## **Engineering Change Notification**

NHD-240128WG-BTFH-VZ# NHD-240128WG-BTMI-VZ#

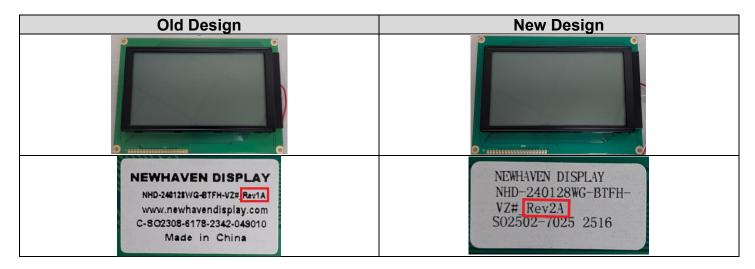
The new display will be labeled with a different revision control number after the part number. See example below.
